# ONYX RANCH SOUTH FORK VALLEY WATER PROJECT

Final Environmental Impact Report  
State Clearinghouse #2018021061

Prepared for  
Rosedale-Rio Bravo Water Storage District

## Final Environmental Impact Report

#### Mill S.

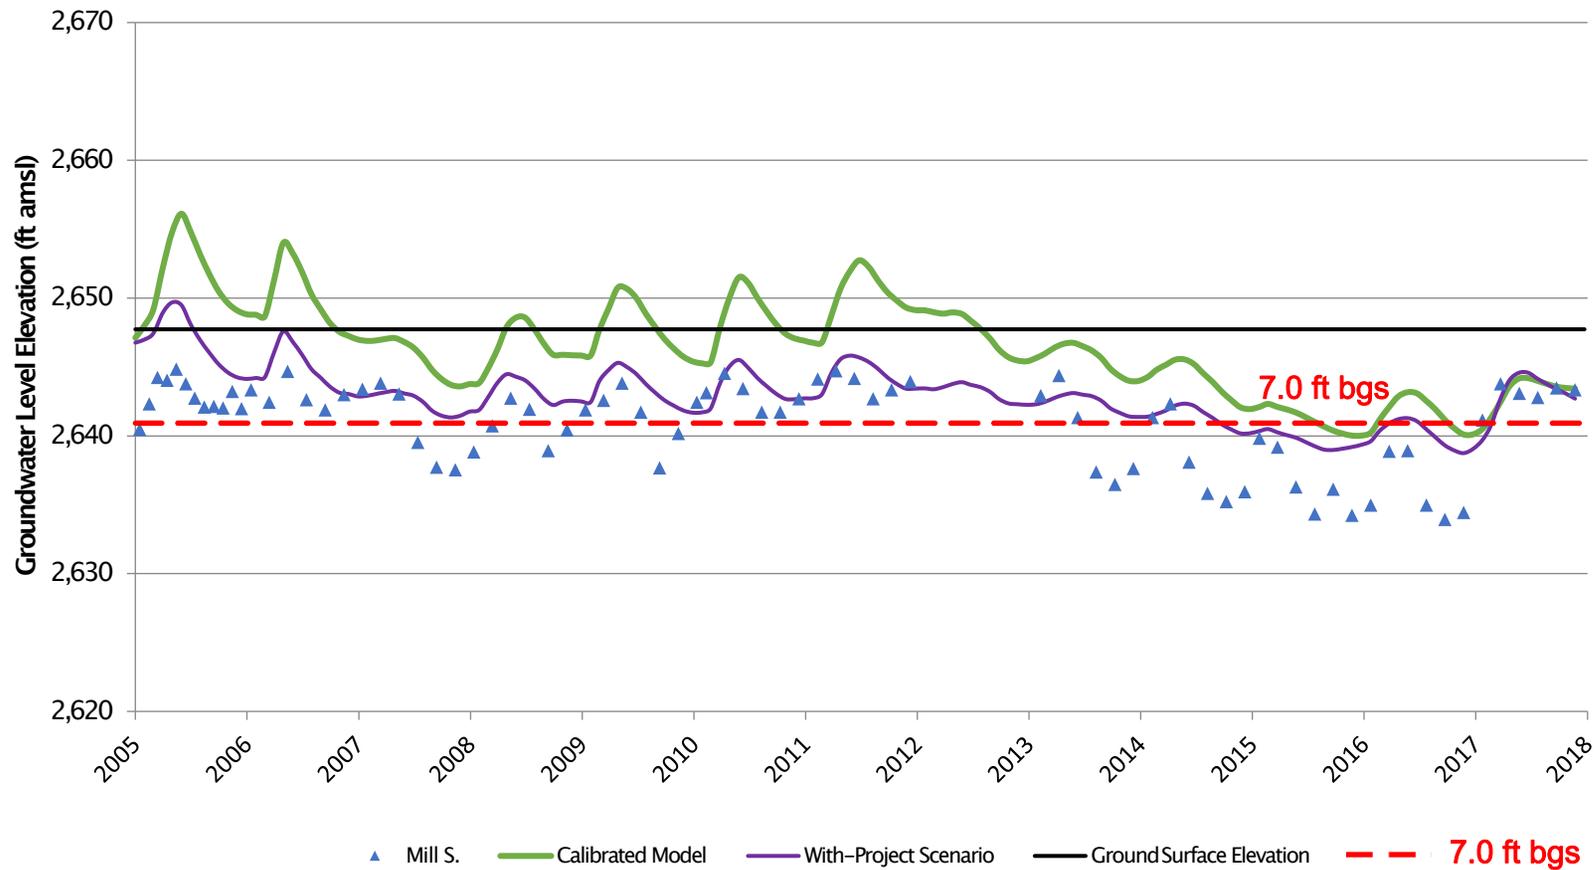
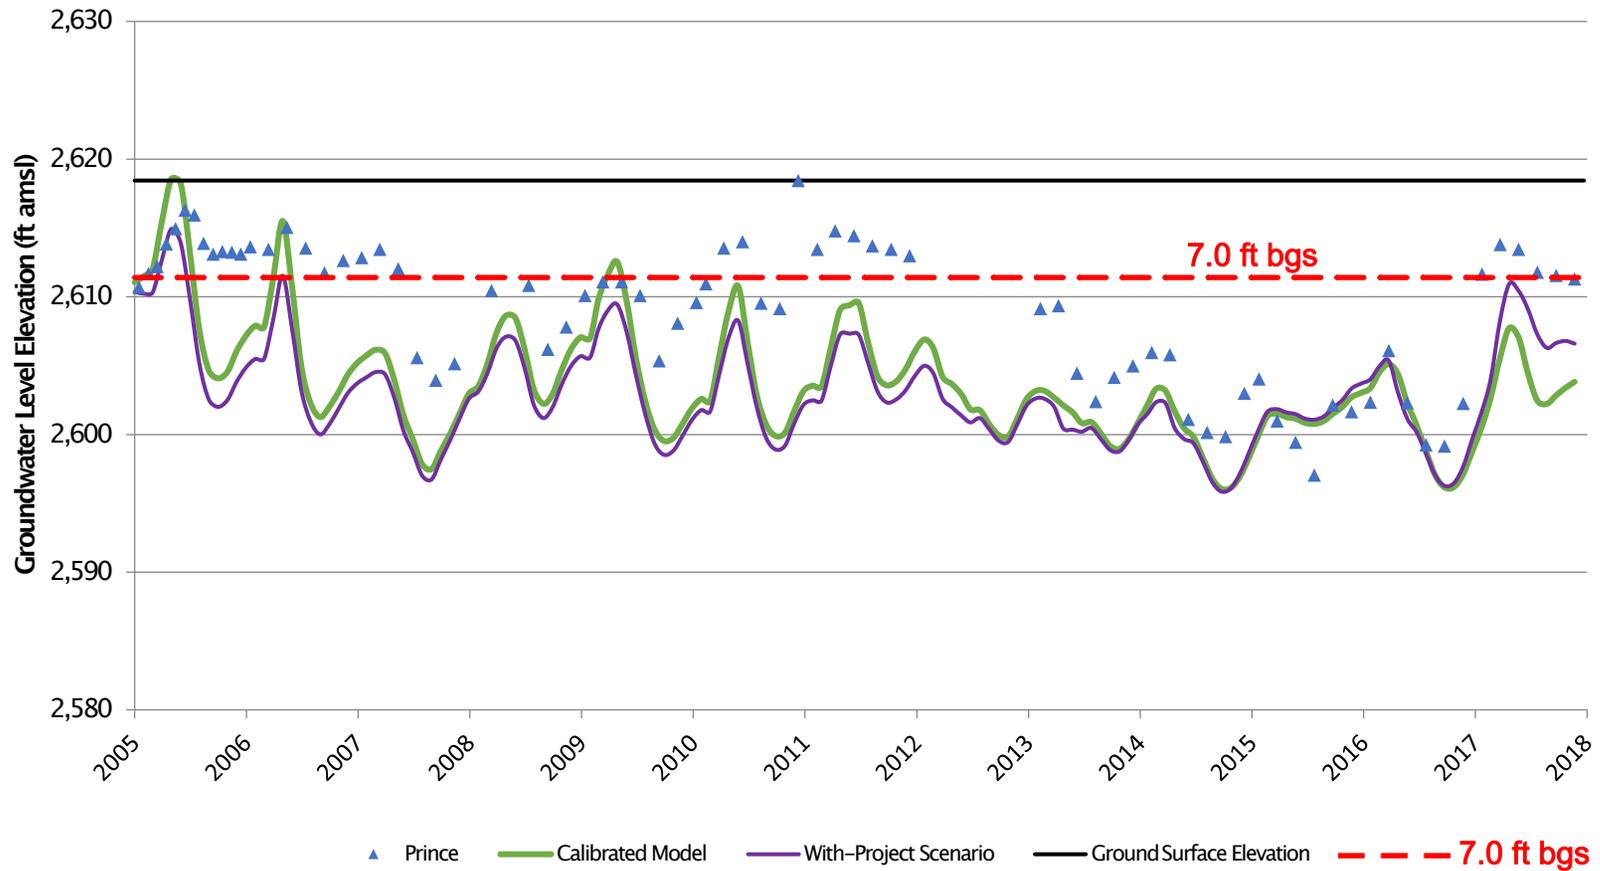
Enclosed with this letter are 11 of the hydrographs for the wells located closest to the South Fork Kern River (from DEIR Figure 3.11-6). On each of these hydrographs, CDFW has added a horizontal line at what approximates a 7-foot depth below ground surface, a depth that can be a critical threshold for preservation of groundwater dependent ecosystems (GDEs) (DEIR page 3.6-57).

The comment is noted for the record. The 11 hydrographs in the attachment to the comment letter show actual measured groundwater levels between 2005 and 2018 at the wells located closest to the South Fork of the Kern River as shown in Figure 3.11-6 of the Draft EIR. The 11 hydrographs show that under existing conditions groundwater levels vary in space and time and have been measured both above and below the 7.0-foot depth below ground surface (bgs), the red line for which has been added by CDFW. As shown by the green lines for the Calibrated Model and the purple lines for the With-Project Scenario, the proposed project would not alter these existing conditions, and groundwater elevations would continue to fluctuate above and below the 7.0-foot depth bgs. It is noted that model results more reliably show relative changes in groundwater

- The 15.6-foot modeled groundwater decrease would occur at the Nicoll Field – Old Ag Well, shown in the Draft EIR, Figure 3.11-6 on page 6.11-32, and would not occur throughout the entire Kern River Valley Groundwater Basin. Decreases in groundwater levels in all other areas would be less. Note that groundwater levels would increase in the area closer to Isabella Reservoir as shown in both Figure 3.11-5 on page 6.11-31 (dry season low groundwater levels) and Figure 3.11-6 (wet season high groundwater levels).

**Root depth thresholds:** While some literature suggests Fremont cottonwood trees are known to have taproots up to approximately seven feet deep, the U.S. Department of Agriculture (USDA) suggests rooting depths in mature Fremont cottonwood stands are up to 16 feet (USDA 2019). Wells HYD-2 and HYD-13 are located in the vicinity of Fremont cottonwood forest as shown in the Draft EIR in Figures 3.6-2a through 3.6-2c and Figures 3.11-5 and 3.11-6. The hydrographs for Wells HYD-2 and HYD-13, which are included in Appendix E of the Draft EIR and Revised Appendix E to this Final EIR, show that once the drought ends, groundwater levels would recover to within the 7- to 16-foot depth interval. Similarly, Wells HYD-1, HYD-4, HYD-9, HYD-11 also are located in the vicinity of Fremont cottonwood forest, and hydrographs for these wells show similar trends of recovery of groundwater levels to within the 7- to 16-foot depth interval following the drought years of approximately 2014 through 2017. Wells Lieb Piezo and Mills S are located on the edge of Fremont cottonwood forest and agricultural fields, and hydrographs for these wells also show similar trends of groundwater level recovery (see Revised Appendix E).

**Figure 9-1**  
Facilities in Vicinity of the Lower Kern River Corridor

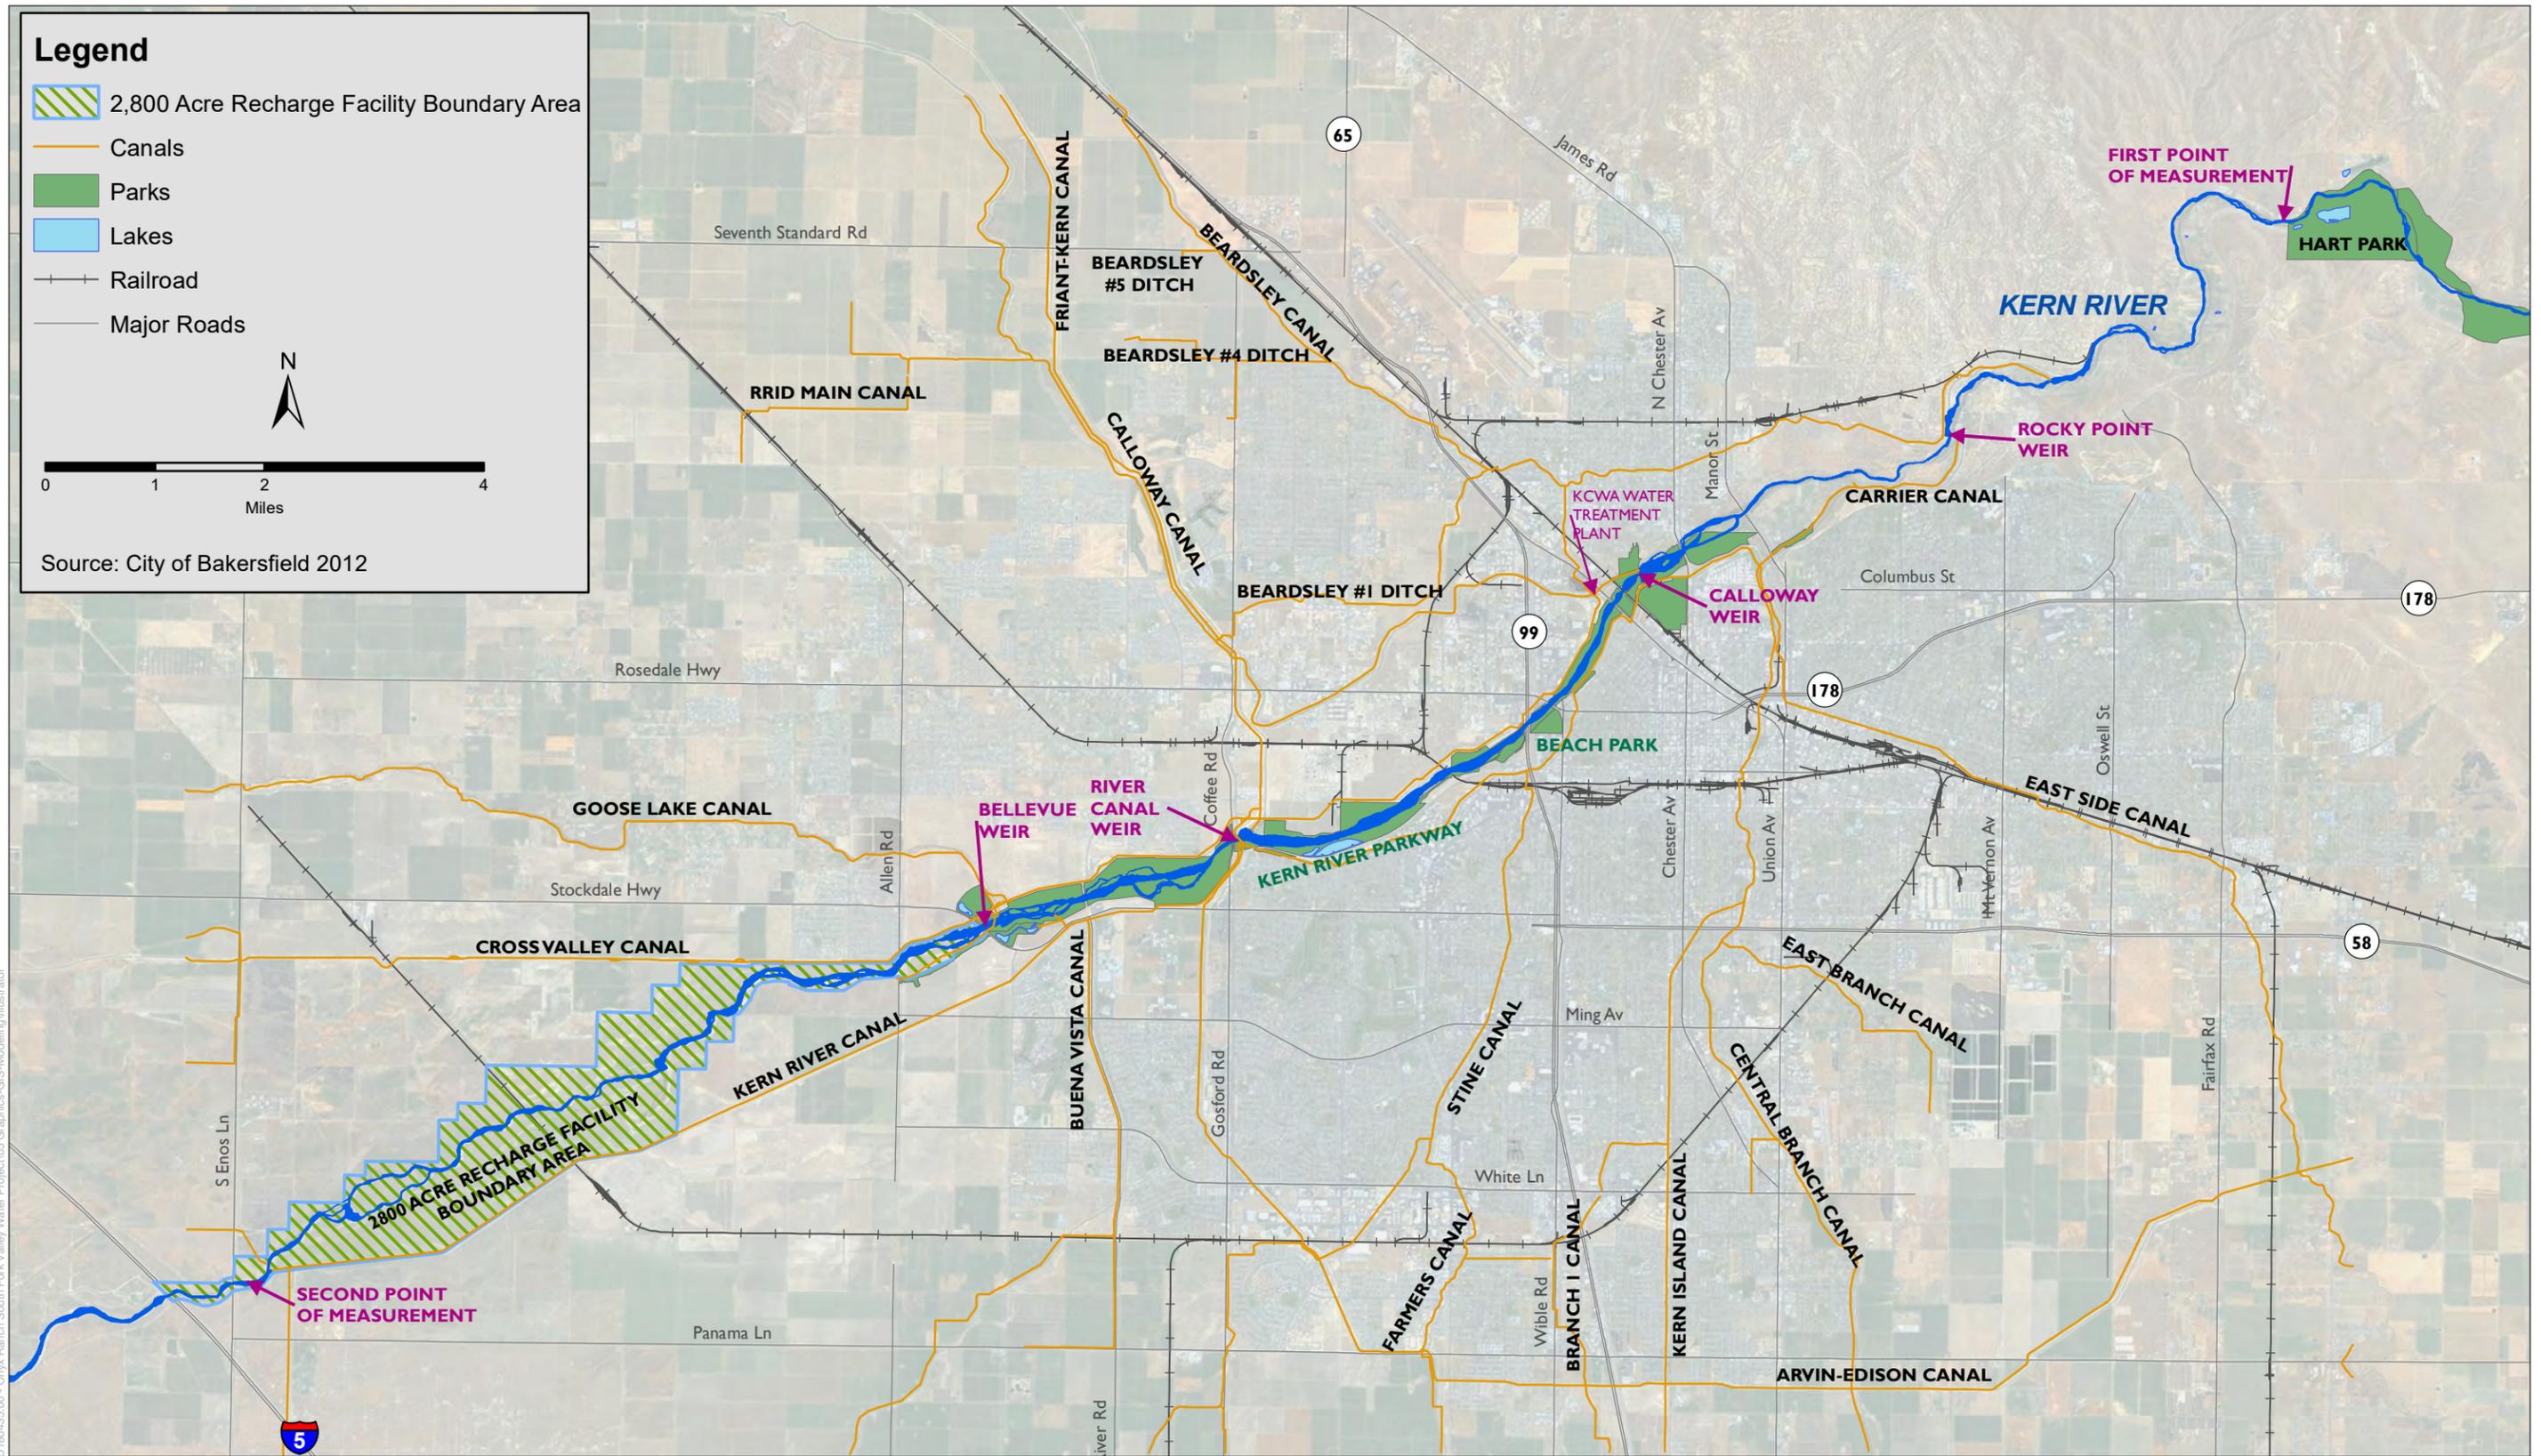
Several comments asked for more detail regarding how the project-related water would move downstream of the Isabella Reservoir through the lower Kern River channel and/or existing off-river canal systems. The project-related water that flows through Isabella Dam would enter the Kern River channel and flow downstream to the Rocky Point Weir, as illustrated in the City of Bakersfield Final EIR for the Kern River Flow and Municipal Water Program, Figure 2-2, provided as Figure 9-1 below. From the Rocky Point Weir, the project-related water could take one of several different paths to reach a groundwater recharge facility.

These complexities were accounted for in the surface-groundwater model developed by Thomas Harder & Co., which was described in the *Hydrogeological Evaluation of the Onyx Ranch Project*, included in the Draft EIR as Appendix E (Thomas Harder & Co., 2019). In response to comments, minor revisions to the model analysis have been made and are described in the *Hydrogeological Evaluation of the Onyx Ranch Project – with Clarification* (Hydrogeological
